Report: TAB REPORT
Function: Test, Adjust, & Balance
Date: 05/25/2023

PROJECT
05-22-23 FREDDY'S OGLETHORPE, GA

Issue List

KEF1
05/25/2023

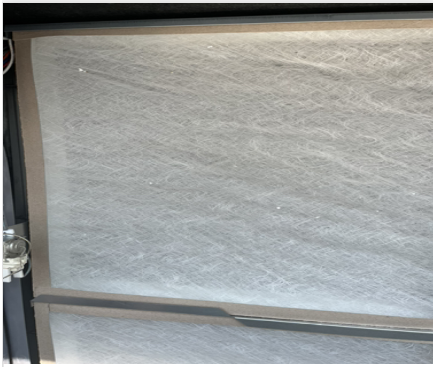
Issue Name : KEF-1 and KEF-2 Hinge Kits
Description : Hinge Kit was not operational on KEF-1 and KEF-2 due to a vented curb extension. This made it so a static pressure could not be safely measured. It is important the fans can be opened easily so that they can be properly maintained and grease ducts effectively cleaned.
Created By : National TAB **Assigned To :** National TAB - William Patton
Status : Open
Originated Date : 05/25/2023 - William Patton - National TAB
